Attachment J3

Submissions

Planning Submission
For: SP 67057: 23 Billyard Avenue, Elizabeth Bay

Development Application ('DA') No. 2023/0727
'Demolition of existing buildings, tree removal, excavation and construction of two new residential flat buildings, 6 to 8 storeys in height, with 22 apartments, 4 basement levels containing 27 car spaces, rooftop terraces, swimming pools and associated landscaping works including new tree plantings. The application is Integrated Development requiring the approval of Water NSW under the Water Management Act, 2000.'

12.00pm Proposed

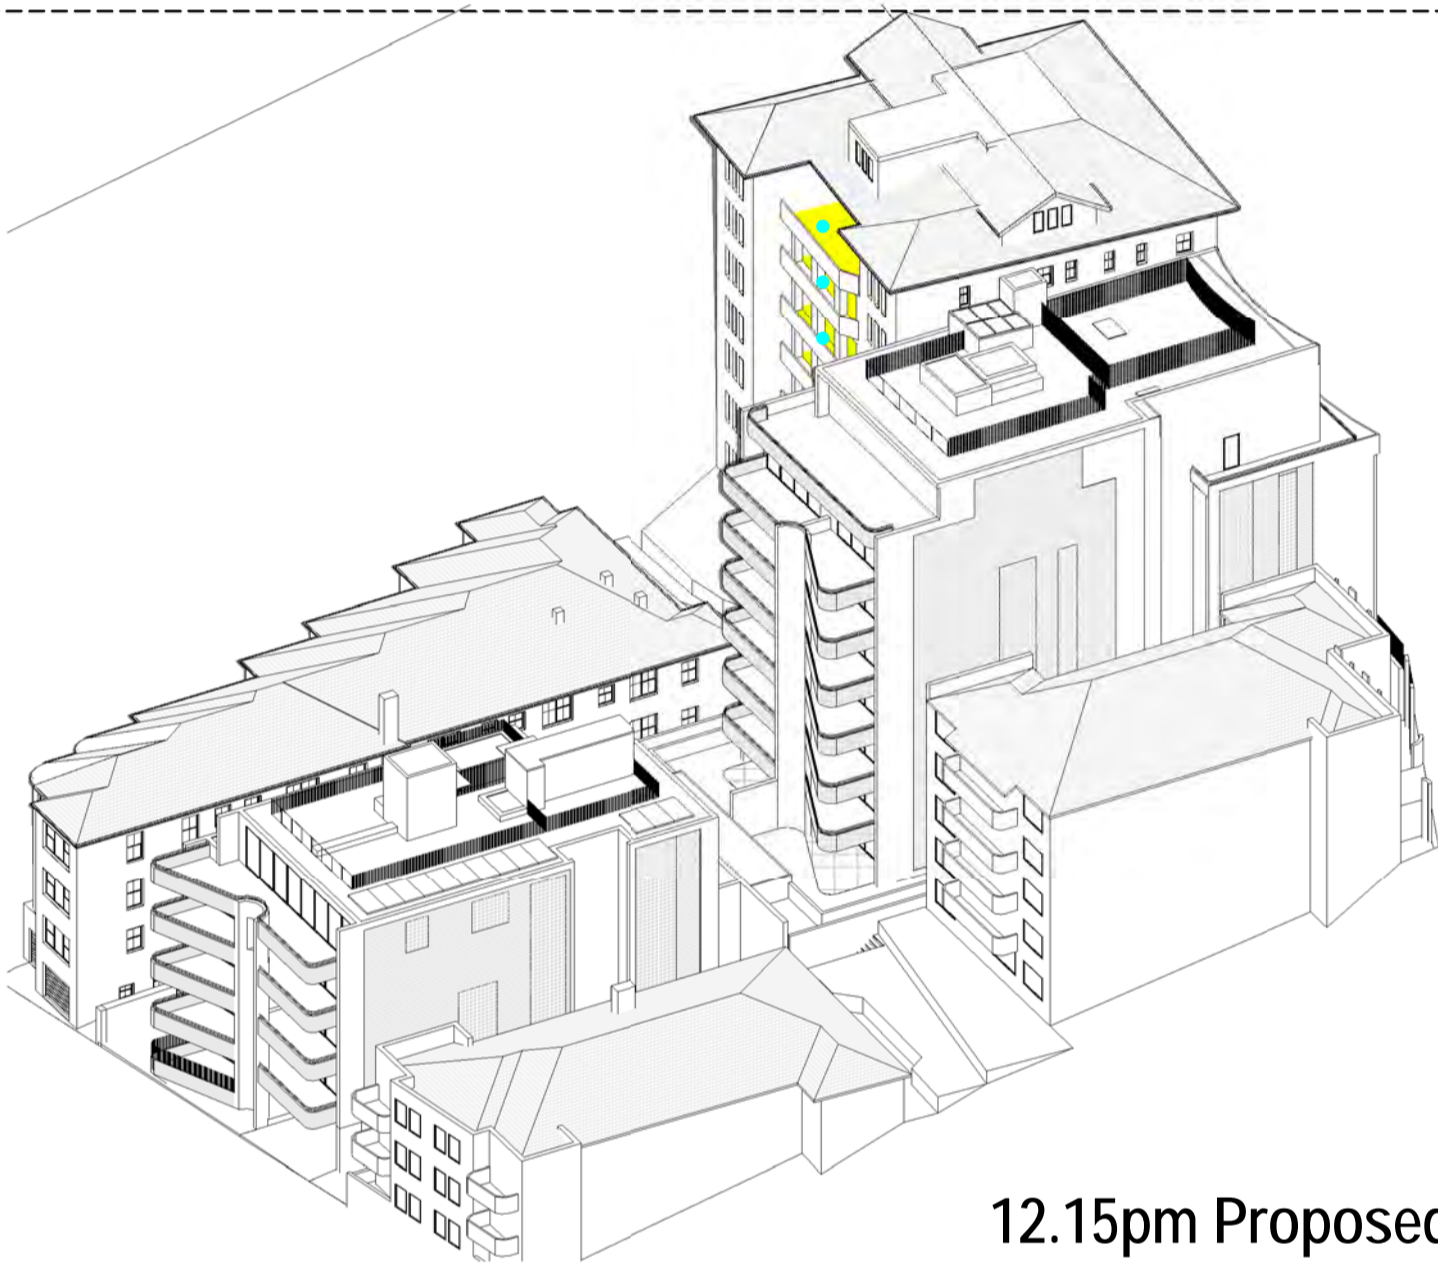
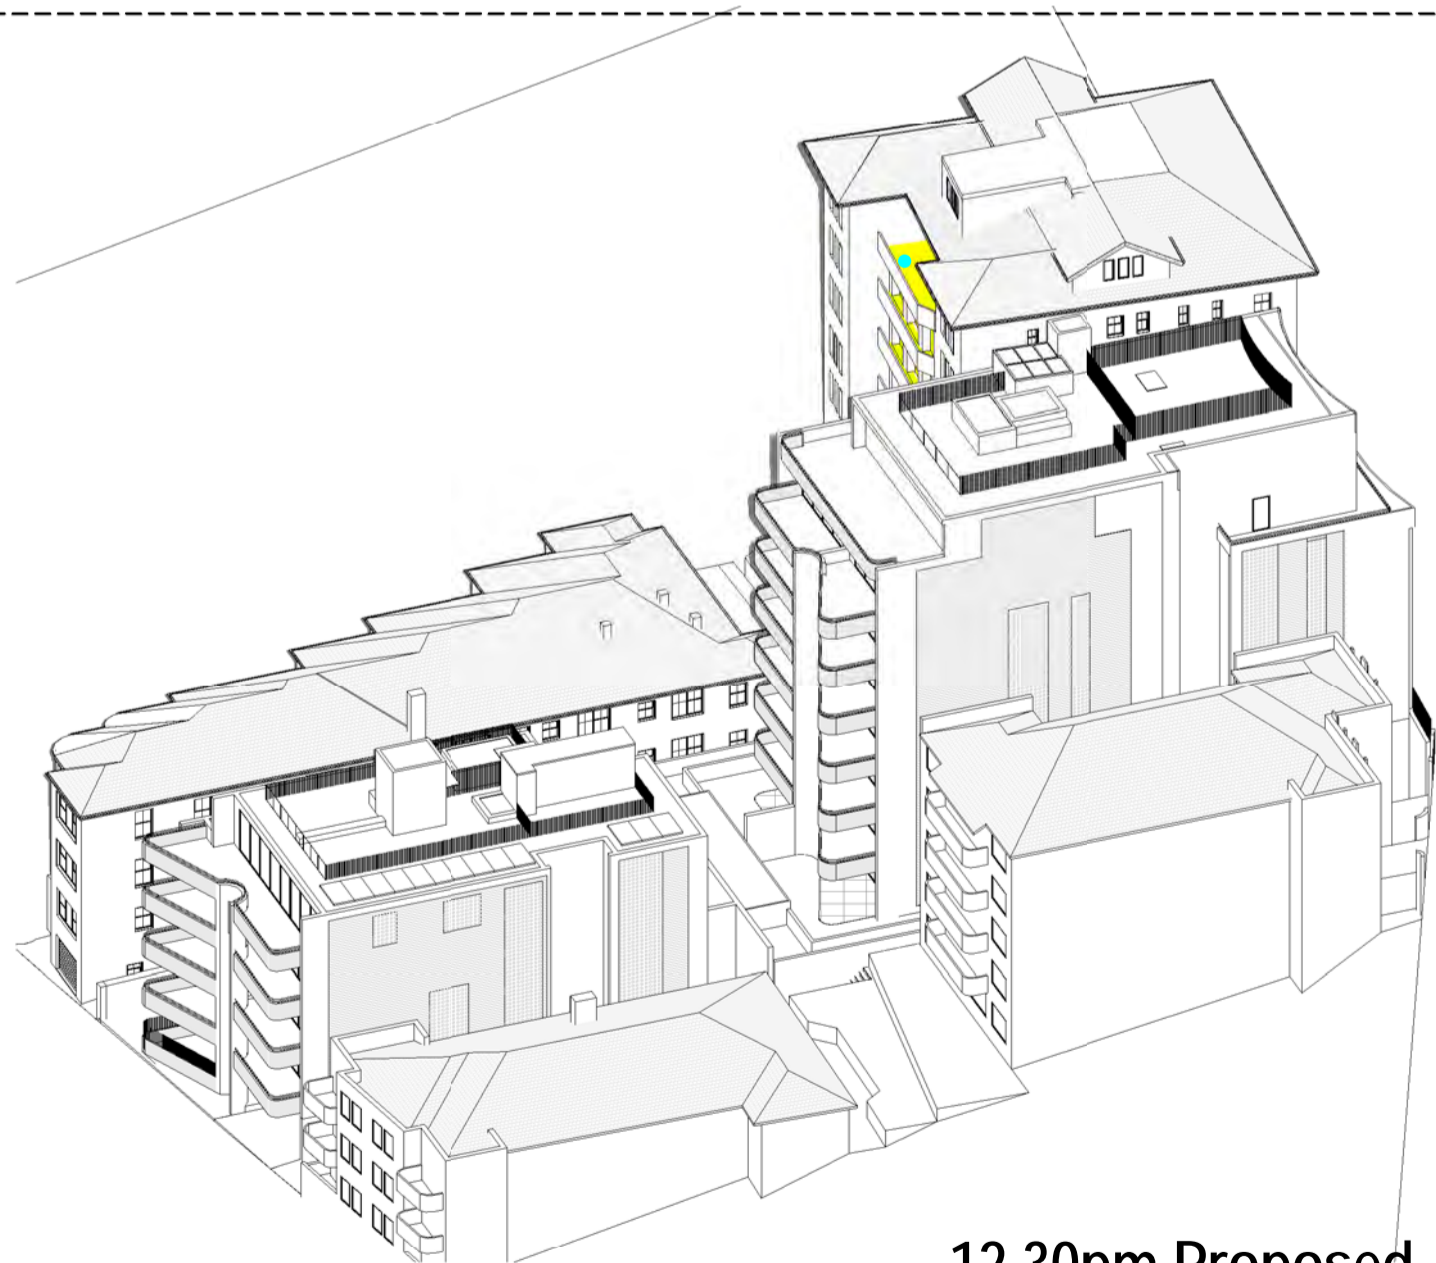
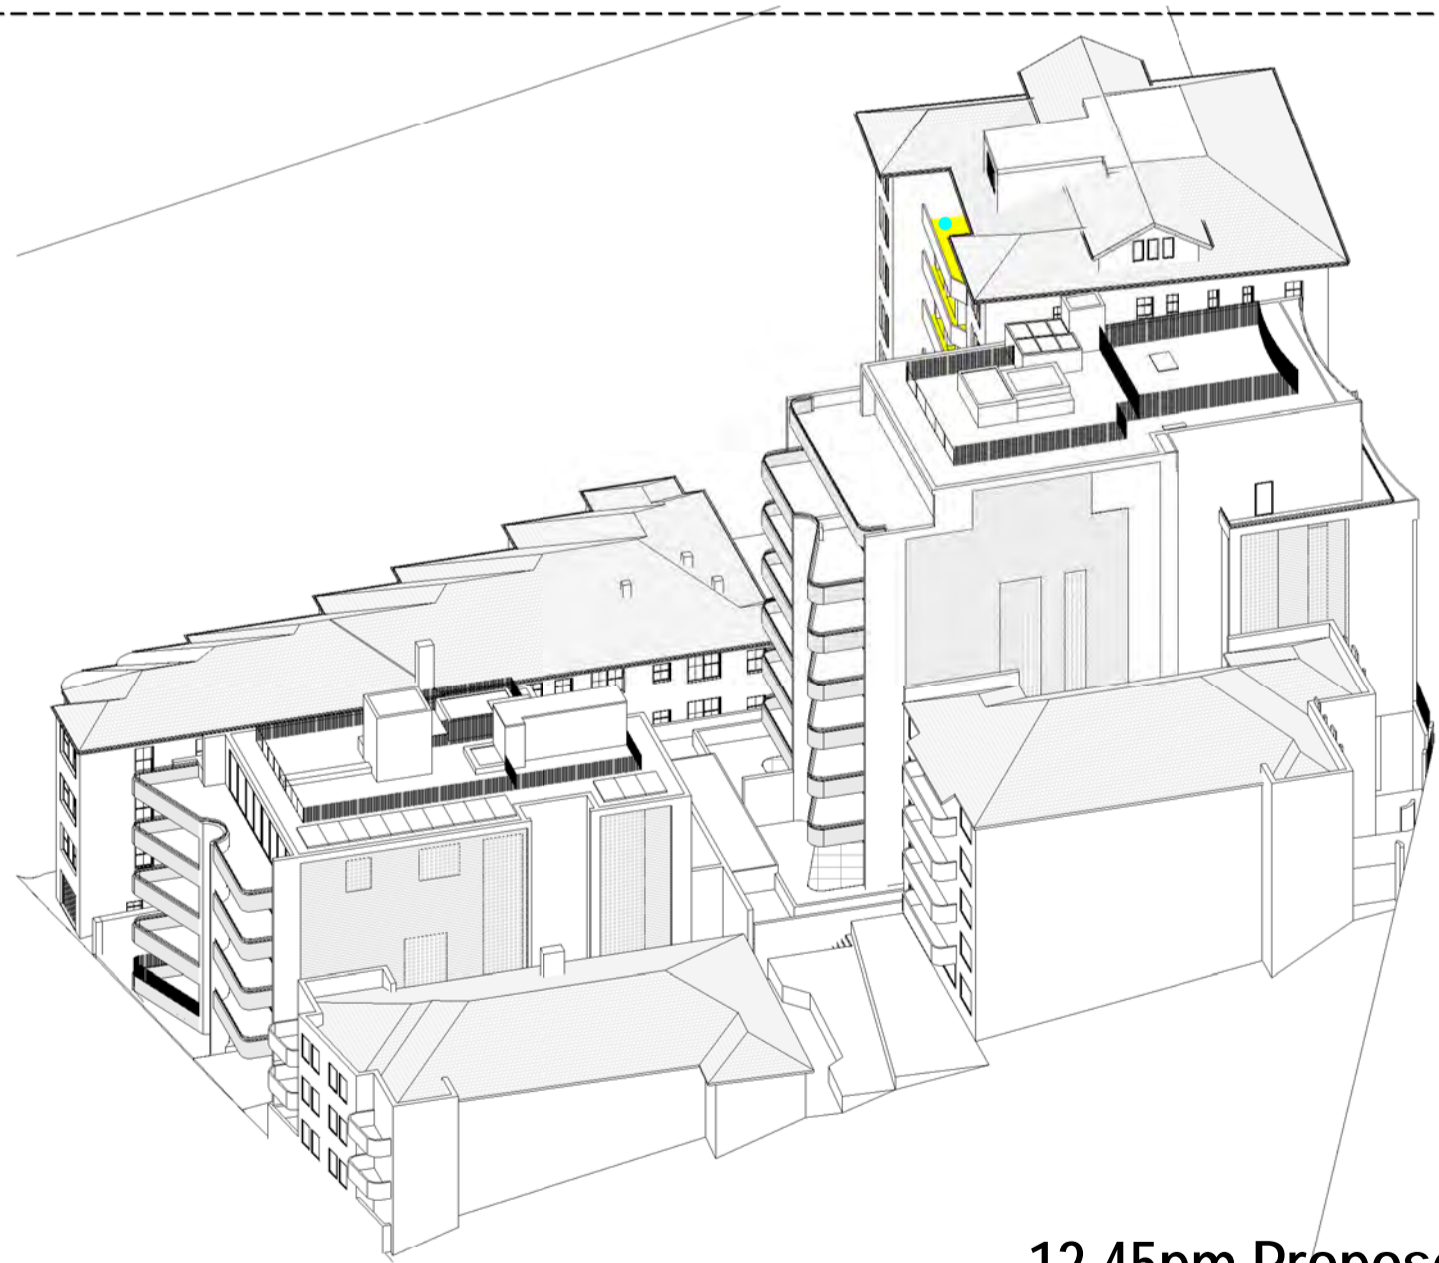
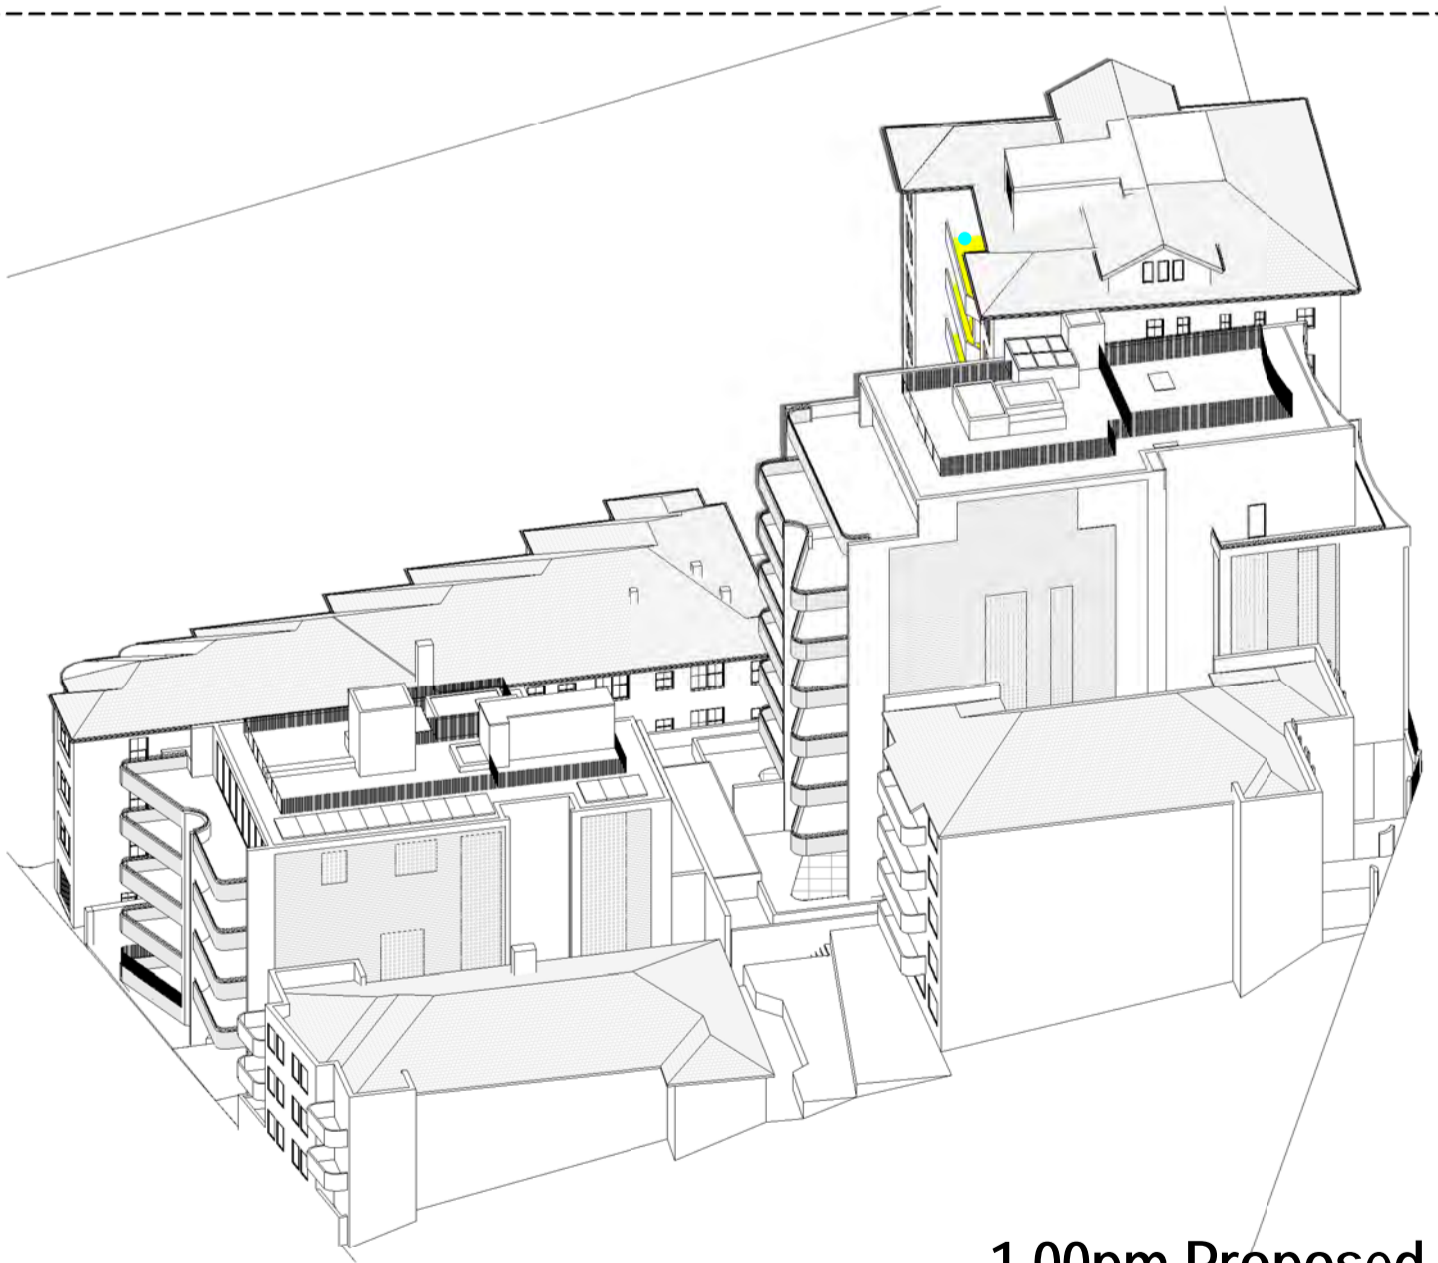
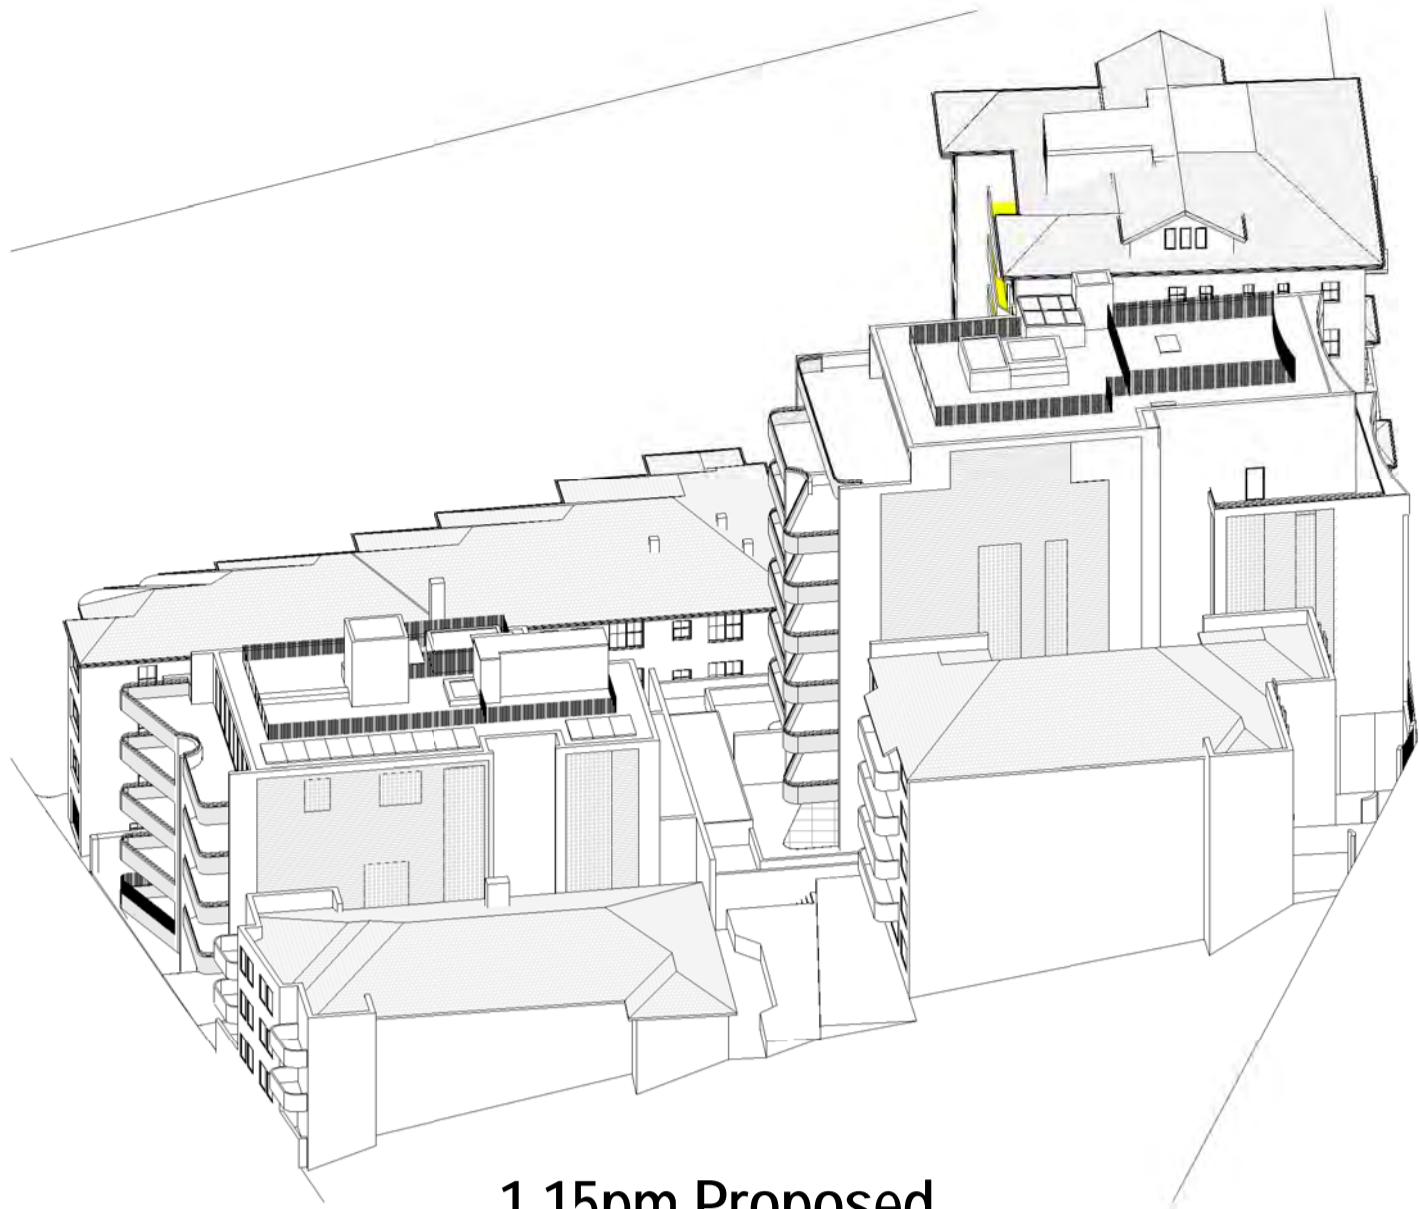
The solar diagrams show worsening of solar access to these only areas of living space (no balconies available). It is noted that staff requested 15 minute intervals and these have not been provided for 23 Billyard Avenue.

1.30	1.45	2.00	2.15	2.30	2.45	3.00	
UNIT 6 LIV	X	X	X	X	X	X	X	
UNIT 7 LIV	X	X	X	X	X	X	X	
UNIT 1 LIV	•	•	•	•	•	•	•	
UNIT 17 LIV	X	X	X	X	X	X	X	
UNIT 18 LIV	•	•	•	•	•	X	X	
UNIT 11 LIV	•	•	•	•	•	•	•	
UNIT 26 LIV	•	•	•	X	X	X	X	
UNIT 27 LIV	•	•	•	•	•	•	•	
UNIT 21 LIV	•	•	•	•	•	•	•	
TOTAL HOURS WINDOWS SOLAR ACCESS JUNE 21ST:								
9.00AM - 3.00PM								
	EXISTING:	PROPOSED:	ACCESS LOST:	% LOST:				
UNIT 6 LIV	0 HOURS	0 HOURS	0	0%				
UNIT 7 LIV	0.25 HOURS	0 HOURS	-0.25 HOURS	100%				
UNIT 1 LIV	6.0 HOURS	2.0 HOURS	-4.0 HOURS	66%				
UNIT 17 LIV	3.25 HOURS	2.25 HOURS	-1.0 HOUR	30%				
UNIT 18 LIV	1.5 HOURS	1.25 HOURS	-0.25 HOURS	16%				
UNIT 11 LIV	6.0 HOURS	2.0 HOURS	-4.0 HOURS	66%				
UNIT 26 LIV	4.25 HOURS	5 HOURS	+0.75 HOURS	+17%				
UNIT 27 LIV	6.0 HOURS	6.0 HOURS	0	0%				
UNIT 21 LIV	6.0 HOURS	3.5 HOURS	-2.5 HOURS	42%
